FORM APPROVED
OMB NO. 1004-0135
Expires: July 31, 2010**SUNDRY NOTICES AND REPORTS ON WELLS**
*Do not use this form for proposals to drill or to re-enter an abandoned well. Use form 3160-3 (APD) for such proposals.***SUBMIT IN TRIPLICATE - Other instructions on reverse side.**

1. Type of Well <input checked="" type="checkbox"/> Oil Well <input type="checkbox"/> Gas Well <input type="checkbox"/> Other		8. Well Name and No. PEACHES 19 FEDERAL 3H
2. Name of Operator OXY USA INCORPORATED		9. API Well No. 30-015-42446-00-X1
3a. Address 5 GREENWAY PLAZA STE 110 HOUSTON, TX 77046-0521	3b. Phone No. (include area code) Ph: 432.685.5717	10. Field and Pool, or Exploratory COTTONWOOD DRAW
4. Location of Well (Footage, Sec., T., R., M., or Survey Description) Sec 19 T25S R27E SESW 0730FSL 1980FWL 32.110024 N Lat, 104.230748 W Lon		11. County or Parish, and State EDDY COUNTY, NM

OXY USA Inc. respectfully requests approval for the following changes to the drilling plan:

Utilize a spudder rig to pre-set surface casing for time and cost savings.

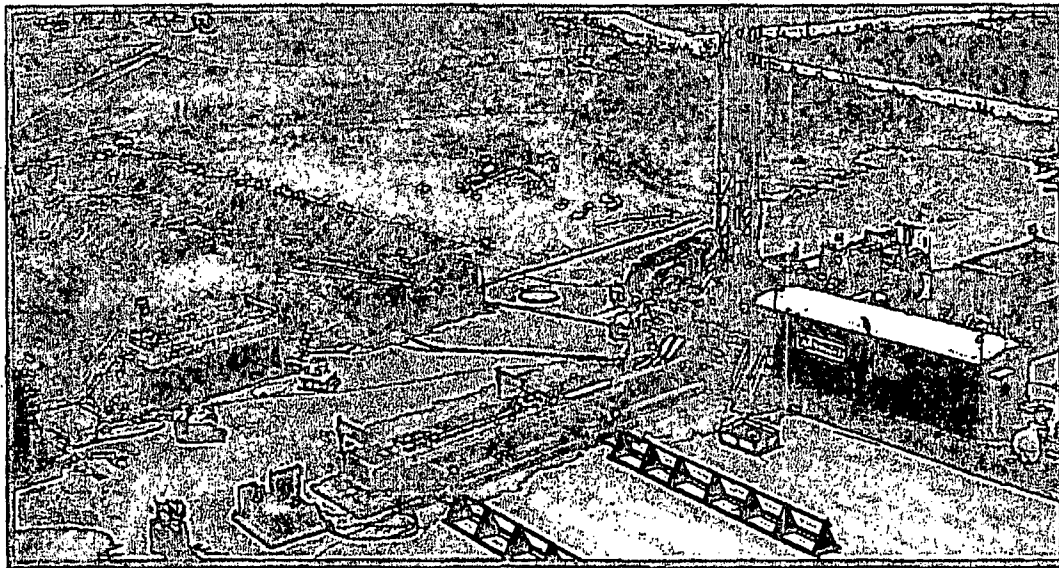
2. The wellhead will be installed and tested as soon as the 10-3/4" surface casing is cut off and the WOC time has been reached.

3. A blind flange as the same pressure rating as the wellhead will be installed to seal the wellbore. Pressure will be monitored with needle valves installed on two wing valves. A means for intervention will be maintained while the drilling rig is not over the well.

6. Drilling operation will start with a larger rig and an approved BOP stack will be nipped up and tested on the wellhead before drilling operations resumes on each well.

Rig #2 Layout (Equipment Layout)

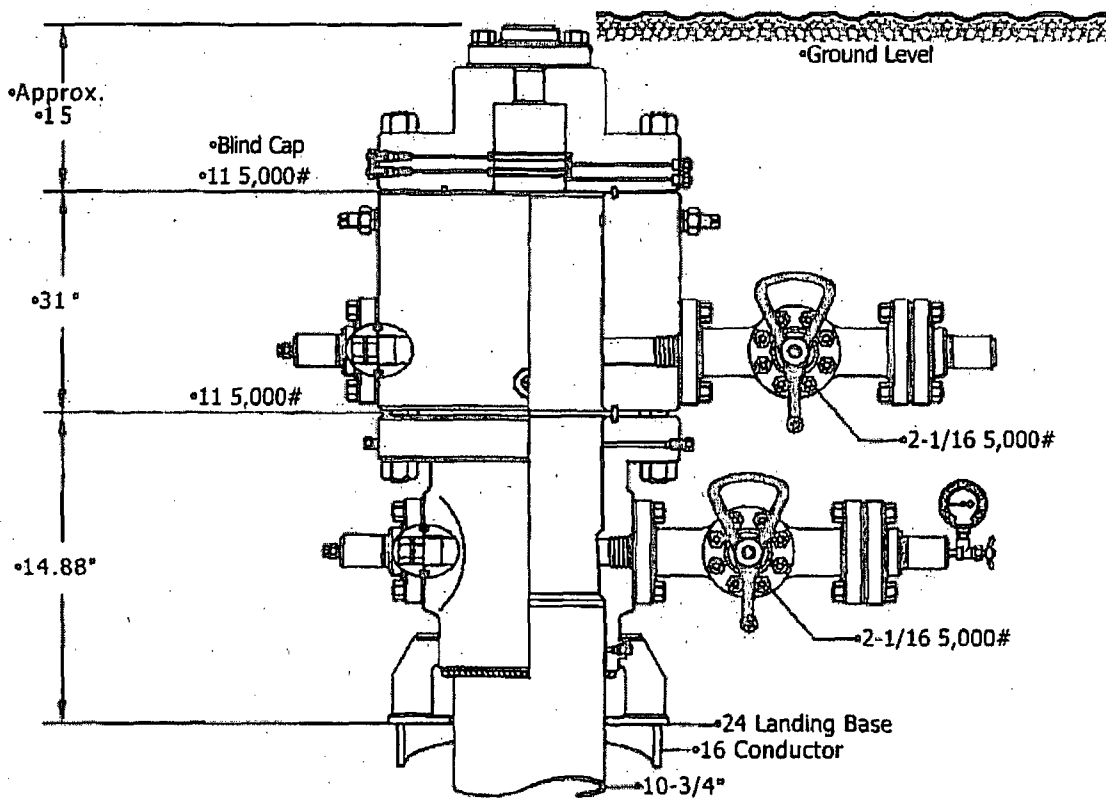
1. Spudder rig contractor Transcend Drilling will move in their rig to drill the surface hole and pre-set surface casing on all of the wells on a given pad.
- a. After drilling each surface hole section, the rig will run casing and cement following all of the applicable rules and regulations (OnShore Order 2, all COAs and NMOCD regulations).
- b. Rig will utilize fresh water based mud, to drill 14-3/4" surface hole to TD. Solids control will be handled entirely on a closed loop basis. No earth pits will be used.

2. Setting surface casing with Transcend Drilling Spudder Rig
 - a. Notify the BLM when removing the Transcend Drilling Spudder Rig.
 - b. Notify the BLM when moving in the H&P Flex Rig. Rig to be moved in within 90 days of notification that Transcend Drilling Spudder Rig has left the location. Failure to notify or have rig on location within 90 days will result in an Incident of Non-Compliance.
